3. AMENDMENTS TO THE DRAWINGS

Attached hereto are two (2) sheets of corrected formal drawings that comply with the provisions of 37 C.F.R. § 1.84. The corrected formal drawings incorporate the following drawing changes:

FIG. 10

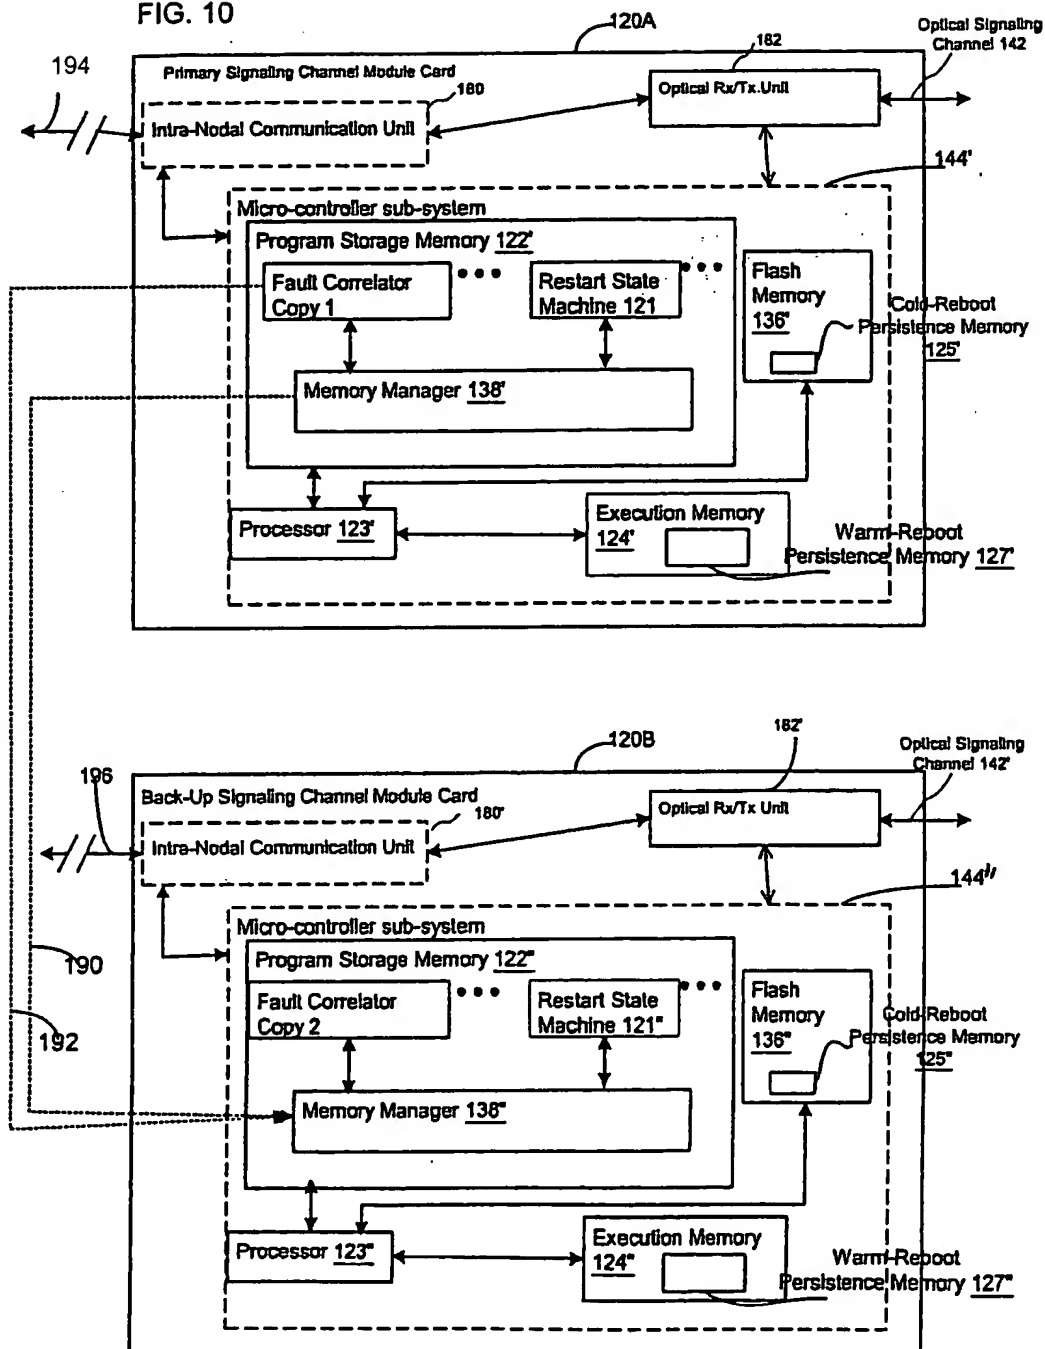
Fig. 10, the reference numeral 144' for module card 120B has been changed to 144"; and

Fig. 10, reference numeral 196 for the communication link from module card 120A has been changed to 194.

FIG. 3

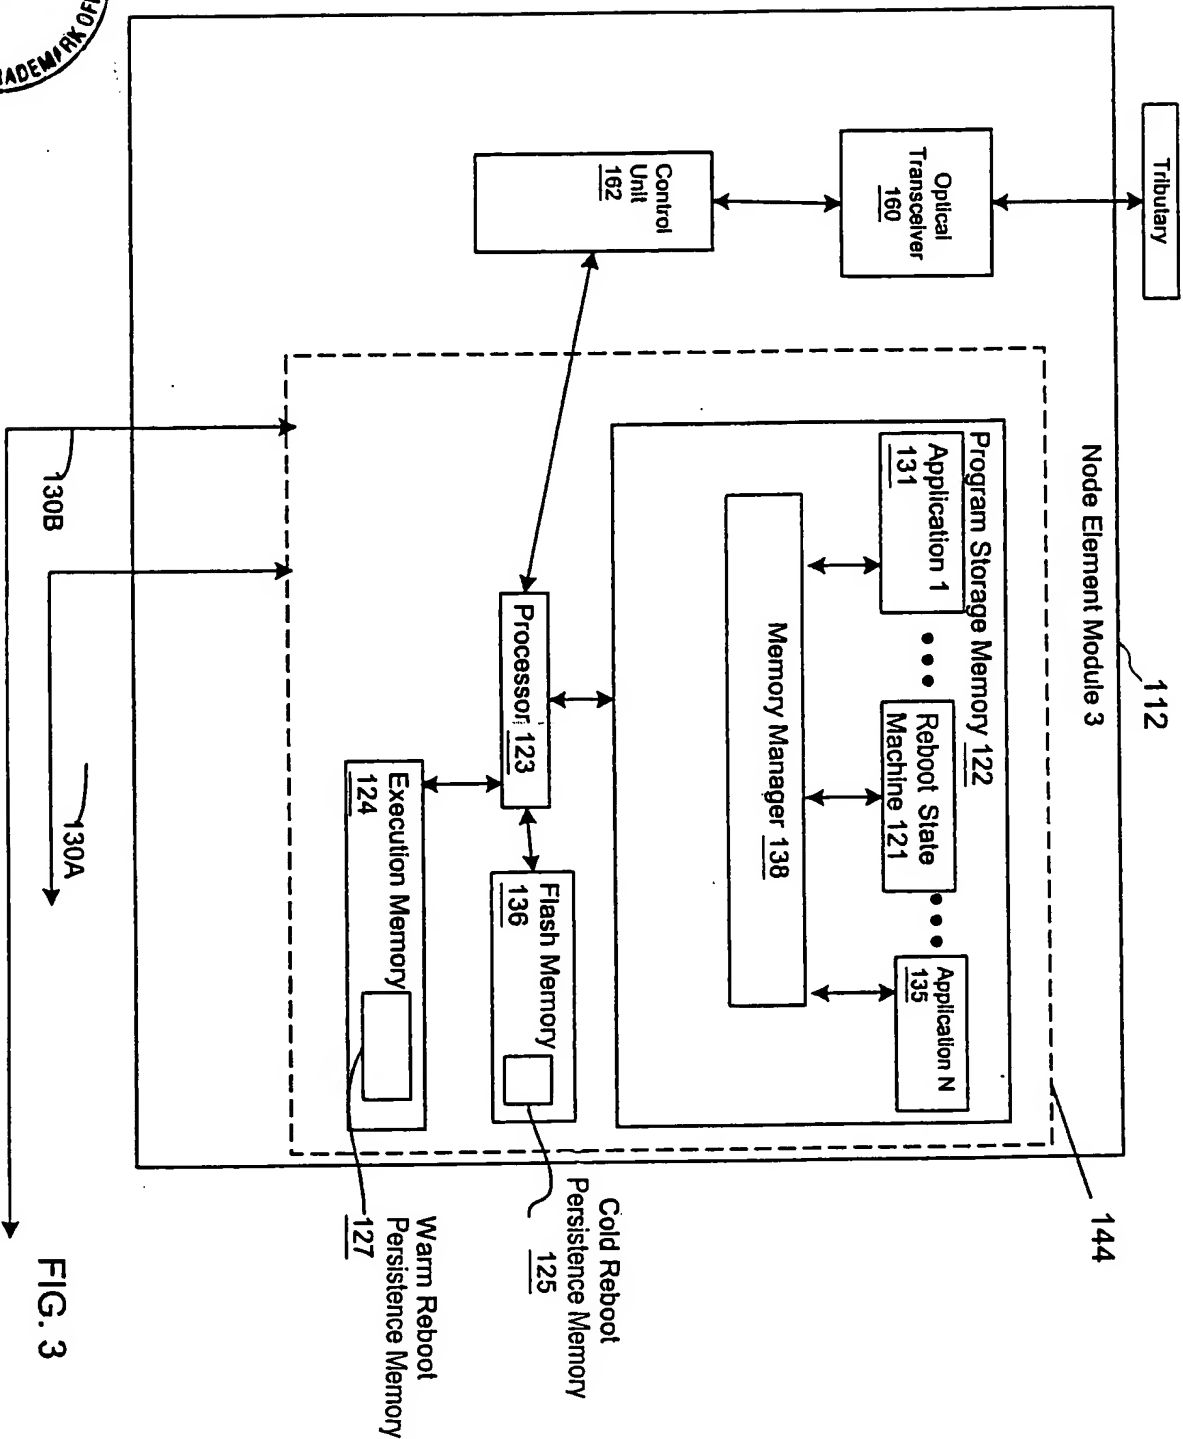
Fig. 3, the word Perisistence above reference numeral 127 has been changed to Persistence Memory;

Fig. 3, the label Cold Reboot Persistence Memory above reference numeral 125 has been moved to the right so that the word Persistence is clearer; and

Fig. 3, within box 121 Restart has been changed to Reboot.
